**MASSACHUSETTS DEPARTMENT OF ENVIRONMENTAL PROTECTION
SOUTHEAST REGIONAL OFFICE
DRINKING WATER PROGRAM
SITE INSPECTION SUMMARY**

Public Water System (PWS): Scituate Water Division
Old Oaken Bucket Surface Water Treatment Plant
4 Old Oaken Bucket Road, Scituate, Massachusetts

SUBJECT: Inspection Of Old Oaken Bucket Surface Water Treatment Plant

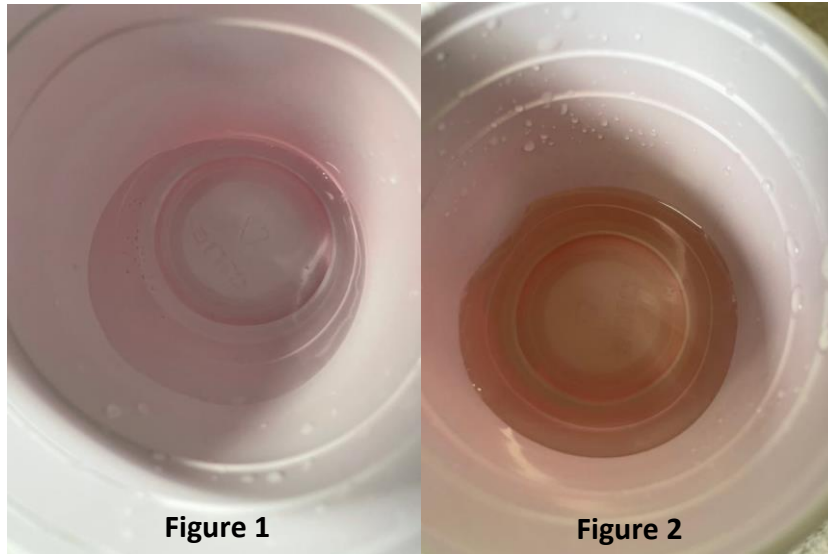
- The effluent from the carbon filter (Figure 1) is clear and colorless in appearance. After chlorination, the clearwell effluent (Figure 2) has a noticeable yellow color. The color of the post chlorination sample is from manganese precipitating out of solution. The operators report that the degree of discoloration is variable and is sometimes much worse than pictured. Post chlorination for disinfection is required by the surface water treatment rule (SWTR) and cannot be eliminated.
